# Access Compliance Report

## Public Rights-of-Way

Intersection ID: 10035582	Main Street: REAMES_RD	Cross Street: N/A	Location: W
ADA ID: B2F38202DE67	Ramp Type: Perp	Initial Pass/Fail: Fail	Overall Compliance: No
Severity Score: 8.75			
Codes/Mitigation Info/Possible Solution		Field Measurements/Component Compliance

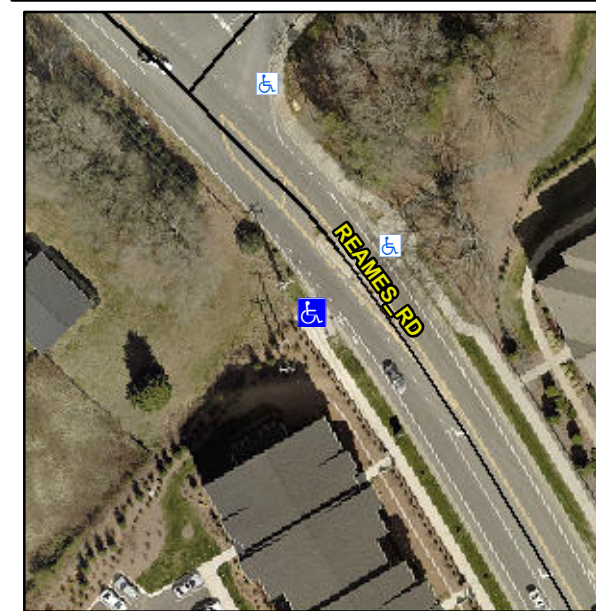
**Not Found, R304.5.1**

Compliance	Description	Data	Compliance	Description	Data
N/A	Ramp Length (in)	71.5	Yes	Ramp Slope (%)	5.9
No	Ramp Width (in)	46.5	Yes	Ramp XSlope (%)	1.2
N/A	Flare Type LT	N/A	N/A	Flare Type RT	N/A
N/A	Flare Slope LT (%)	N/A	N/A	Flare Slope RT (%)	N/A
N/A	Flare Traversable LT?	N/A	N/A	Flare Traversable RT?	N/A
N/A	Landing Length (in)	N/A	N/A	DWS Provided?	N/A
N/A	Landing Width (in)	N/A	N/A	DWS Contrast?	N/A
N/A	Landing Slope (%)	N/A	N/A	DWS Length (in)	N/A
N/A	Landing X Slope (%)	N/A	N/A	DWS Full Width?	N/A
N/A	Landing Curb? (Y/N)	N/A	N/A	DWS Offset (in)	N/A
N/A	Shared Landing?	N/A			
N/A	Gutter Ponding?	N/A	N/A	Gutter Slope (%)	N/A
N/A	Gutter Lip Ht (in)	N/A	N/A	Gutter X Slope (%)	N/A
N/A	Painted X Walk1?	No	N/A	Painted X Walk2?	N/A
	X Walk 1 Direction	To E		X Walk 2 Direction	N/A
N/A	X Walk 1 Width (in)	N/A	N/A	X Walk 2 Width (in)	N/A
	X Walk 1 Slope (%)	2.4		X Walk 2 Slope (%)	N/A
	X Walk 1 X Slope (%)	0.2		X Walk 2 X Slope (%)	N/A

**Remove & Replace Entire Ramp.**
